Subject: 8 Southwood Lawn Road - HGY/2023/0861

We have received the revised draft plans.

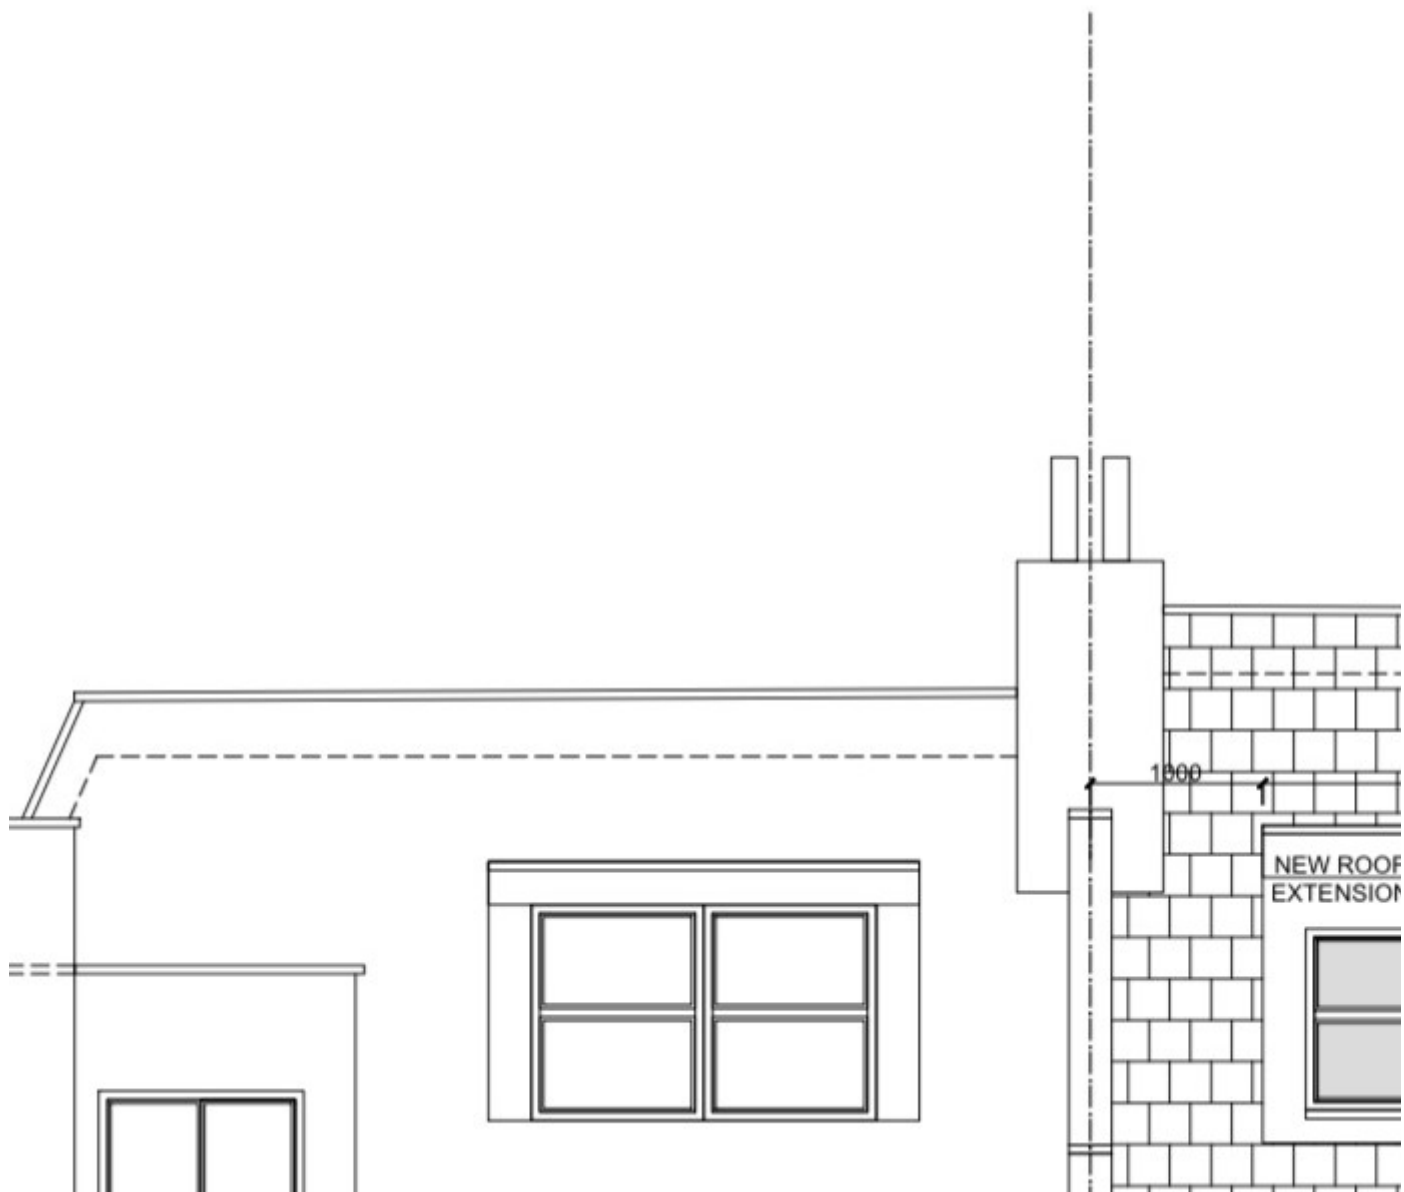
However we still object to the application due to the height of the GF extension wall and loss of light to 6 Southwood Lawn Road GF rear.

The sloping roof helps to reduce the height of the boundary wall and goes some way to resolving our concerns, but still removes all light from our adjacent window which is not in line with Haringey Development Management DPD and the BRE Site Layout Planning for Daylight and Sunlight: a guide to good practice. So unfortunately we are not satisfied with the current revised plan.

new wall
3.05m
high
at
boundary
of 6+8 SLR

1. Maximum height of extension be reduced by 50cm to a max of 3.1 metres. Current proposal is max 3.615 metres. Due to the difference in site level of 55 cm this makes the current proposal 3.05 m at the boundary and 4.165m within 1.1 m of the boundary
2. The new extension wall is built from the party wall ground level at 6 SLR. Current revised plan shows the wall starting at 8SLR garden height and does not address what happens to the lower portion of the party wall (where the difference in site levels occurs). This needs to be resolved through the party wall agreement.
3. Sloping roof is either solid or obscured glass (clear glass would result in overlooking of 6 SLR)

Loss of
Light

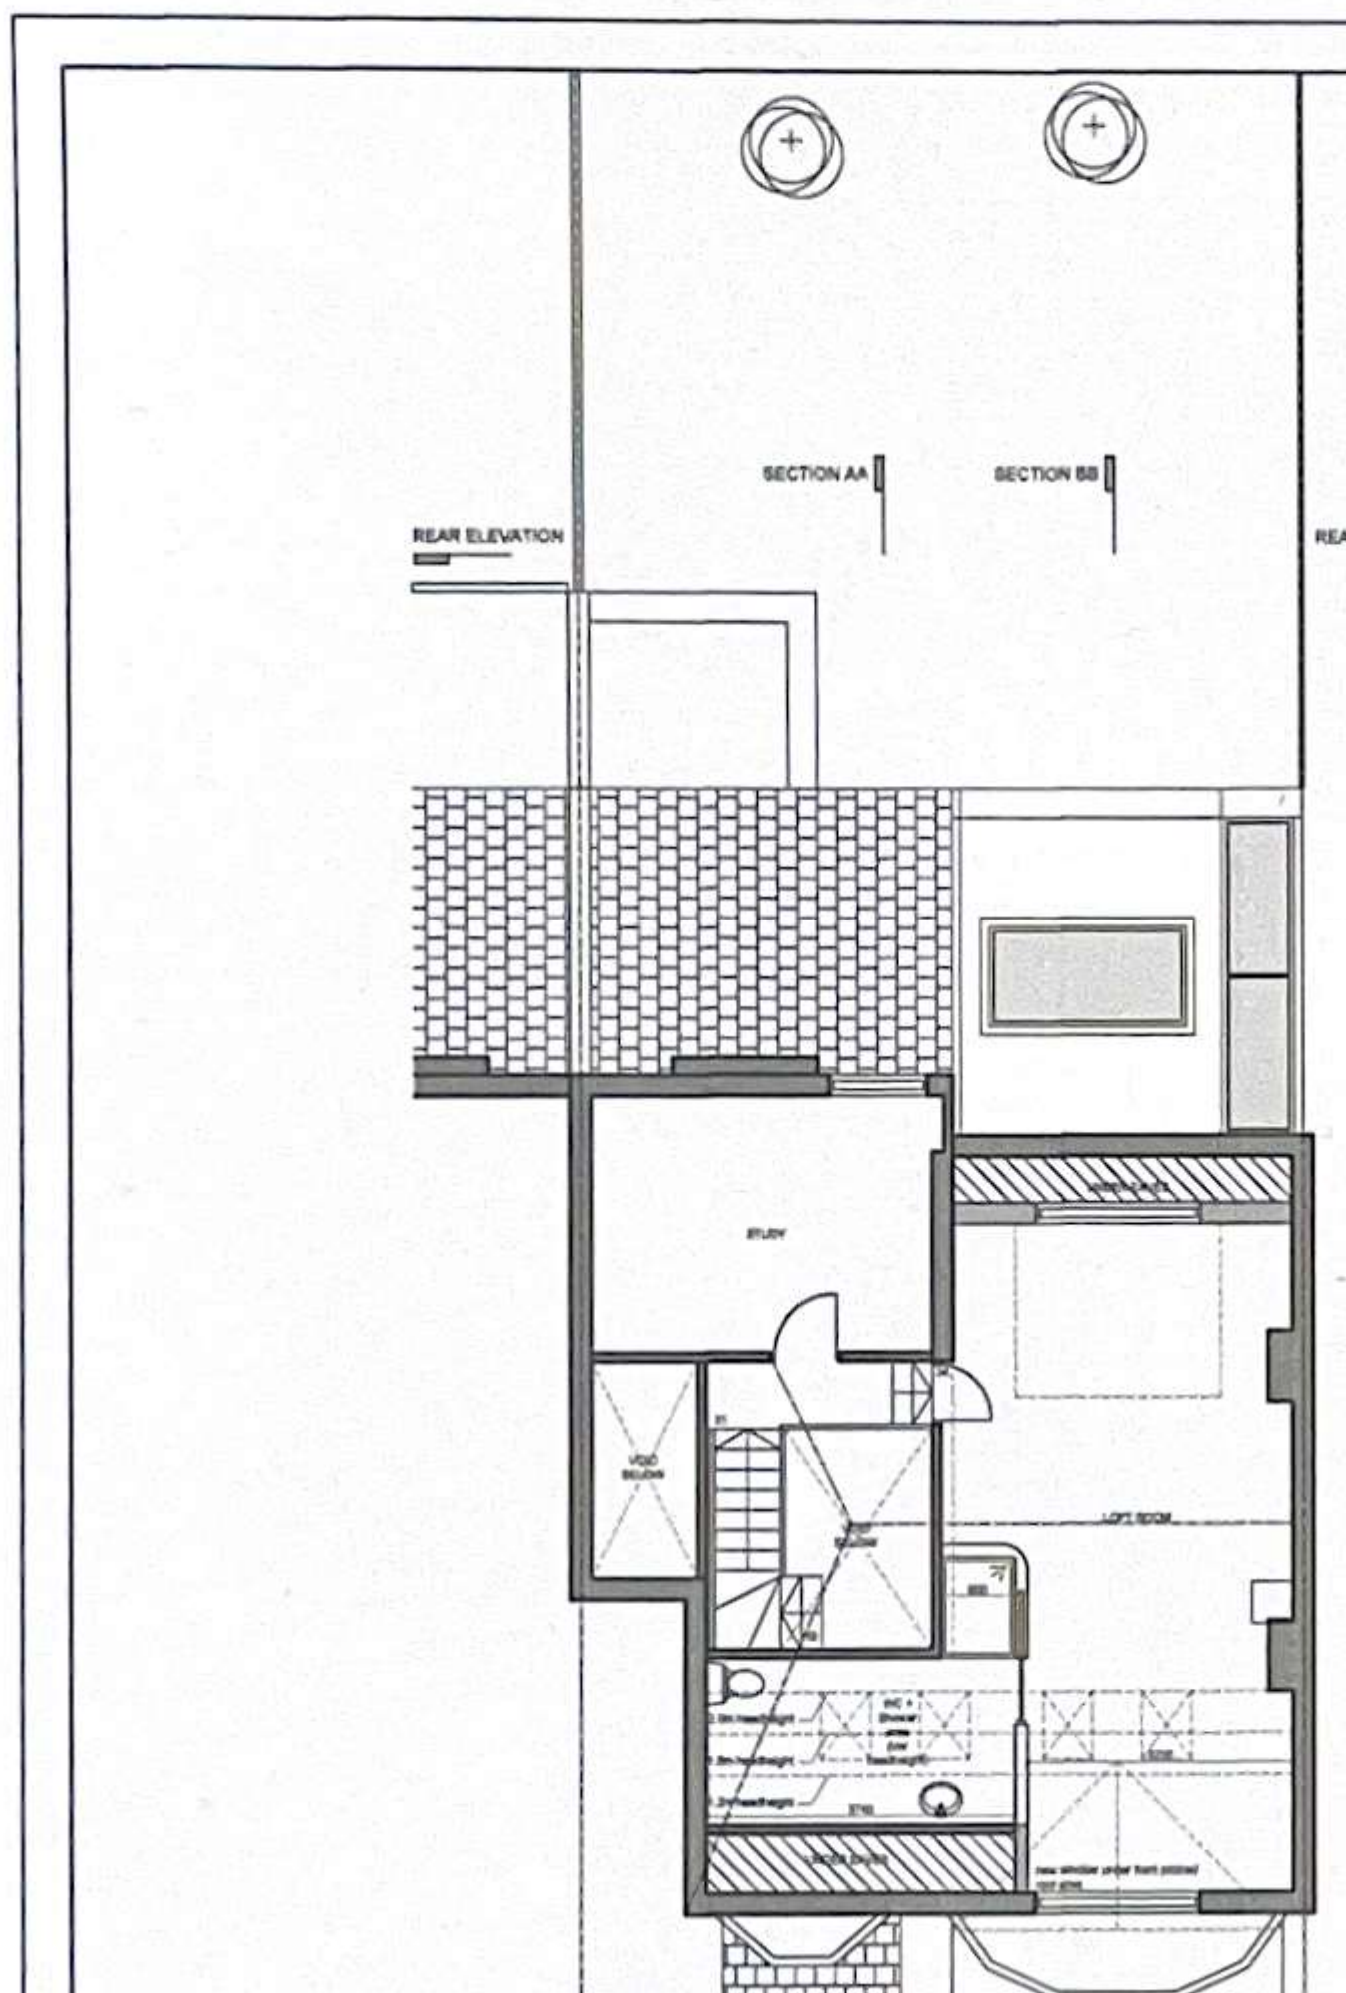
The architect did not show the 6SLR windows on the revised plan. This would have been transparent.

I have tried to draw them on the attachments below. Please forgive my amateur drawings. The drawing and photograph show the location of our window and patio doors.

Existing
patio
windows
lose some
light

Existing
Window
Loses all
New

also be reduced by c50 cm because the height of the new GF extension room adjacent to 6SLR is unnecessarily high. This has not yet been incorporated in the revised plan.
